Addendum #5 to Change Technical Specifications, Change Drawings, and respond to questions submitted. Please note that page 22 of 35 in the addendum package contains the calendar that was in the original bid package and does not reflect the closing date updated in addendum #4.

**Placement Area 8 – Dike Relocation**

September 26, 2025

CONSTRUCTION ACCESS ROUTES

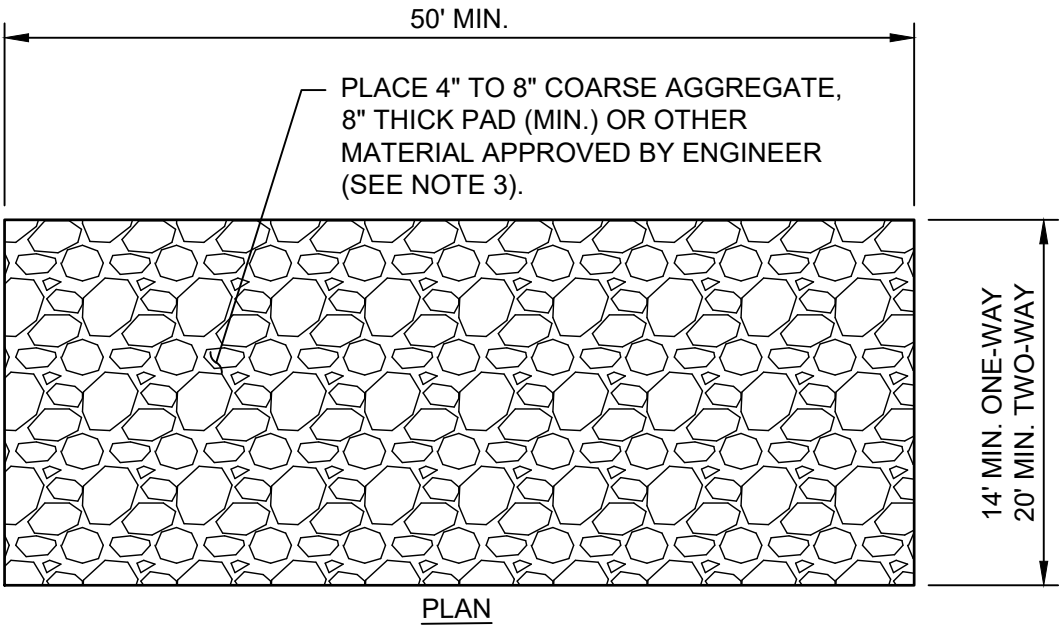
- a. Sheet 01G-01, "CONSTRUCTION ACCESS POINTS".
  - i. Delete: Sheet 01G-01, rev. 0 in its entirety.
  - ii. Add: Sheet 01C-01, rev. 1 in its entirety (Attachment C01).
- b. Sheet 01C-01, "EXISTING CONDITIONS".
  - i. Delete: Sheet 01C-01, rev. 0 in its entirety.
  - ii. Add: Sheet 01C-01, rev. 1 in its entirety (Attachment C02).
